ADA Curb Ramp New Construction Inspection Form (Parallel)

Main	24952.54			Wascoe	
North-South Road Name	Project No.	Sheet No.	Intersection No.	East-West Road Name	See https://www.oregon.gov/odot/Engineering/Documents_RoadwayEng/ADA_ExhibitA.pdf for more corner styles. Use Washington County corner numbering system.
Calibration Date 10/8/2024 (mm/dd/yy)

PARALLEL RAMP (PL)

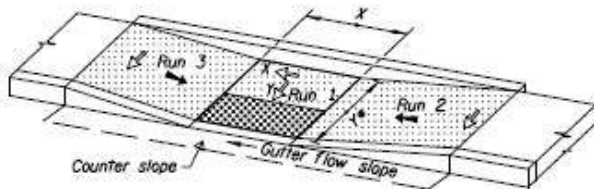
RAMP RUN 1		Pass	Fail
Running Slope 1	2.8 $\leq 2.0\%$ <input type="checkbox"/> $> 2.0\%$ <input checked="" type="checkbox"/>		
Cross Slope 1	2.0 $\leq 2.0\%$ <input checked="" type="checkbox"/> $> 2.0\%$ <input type="checkbox"/>		
Detectable Warning	Y Y <input checked="" type="checkbox"/> N <input type="checkbox"/>		
Lip Height	0 $\leq 1/4"$ <input type="checkbox"/> $> 1/4"$ <input type="checkbox"/>		
Gutter Flow Slope	0.8 $\leq *$ <input checked="" type="checkbox"/> $> *$ <input type="checkbox"/>		
Curb Running Slope (avg)	<input type="checkbox"/> 1.52 $\leq 8.3\%$ <input type="checkbox"/> $> 8.3\%$ <input type="checkbox"/>		
Counter Slope (+/-)*2	7.4 $\leq 5.0\% $ <input checked="" type="checkbox"/> $> 5.0\% $ <input type="checkbox"/>		
Det. warning full width of ramp	Y Y <input checked="" type="checkbox"/> N <input type="checkbox"/>

RAMP RUN 3		Pass	Fail
Running Slope 3	<input type="text"/> $\leq 8.3\%$ <input type="checkbox"/> $> 8.3\%$ <input type="checkbox"/>		
Length 3	7.35		
Cross Slope 3	3.5 $\leq 2.0\%$ <input type="checkbox"/> $> 2.0\%$ <input checked="" type="checkbox"/>

IITD gt2. Rr2 is grass. No end of walk barricade.
